REVIEW OF CORROSION ASPECTS OF HIGH-LEVEL WASTE STORAGE TANKS AT WEST VALLEY

**Nuclear Regulatory Commission
Contract NRC-02-88-005**

**Center for Nuclear Waste Regulatory Analyses
San Antonio, Texas**

April 1993

Figure 3-1. Effect of NaNO₂ and NaOH on SCC of A 285-B steel in 5 M NaNO₃ solution at 97°C. (Ondrejcin, 1979)

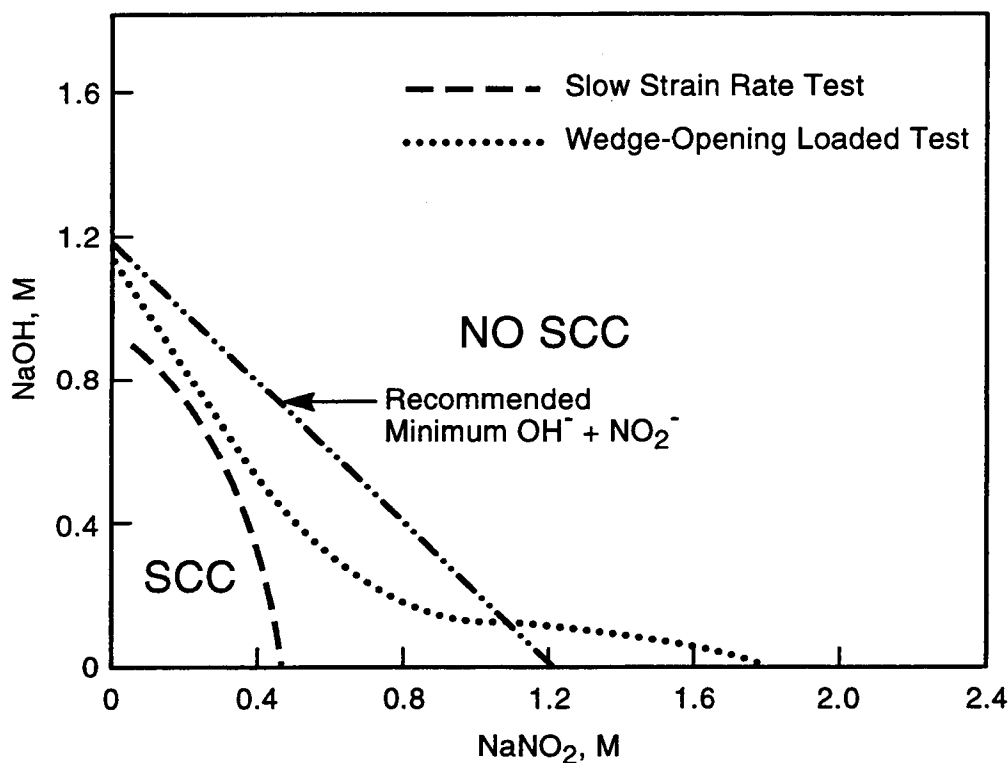
The previous discussion on SCC studies suggests that in the West Valley tanks the occurrence of SCC may be prevented by the presence of relatively high concentrations of nitrite and hydroxide with respect to that of nitrate, as shown by Table 2-2. The combined concentrations of OH^- and NO_2^- anions define a point located in the noncracking region of Figure 3-1. In addition, the concentration of NO_3^- in the 8D-2 tank is 1 M rather than 5 M as in the data shown in Figure 3-1 and the temperature is lower than 97°C . Therefore, it can be expected that the initiation and growth of stress corrosion cracks is inhibited. This consideration of environmental factors seems to be a valid approach for evaluating the potential risk of environmentally assisted cracking in the case of West Valley tanks. However, changes in the chemical composition of the waste or variations in temperature and corrosion potential may lead to the occurrence of cracking, which makes a monitoring and inspection program fully justifiable.
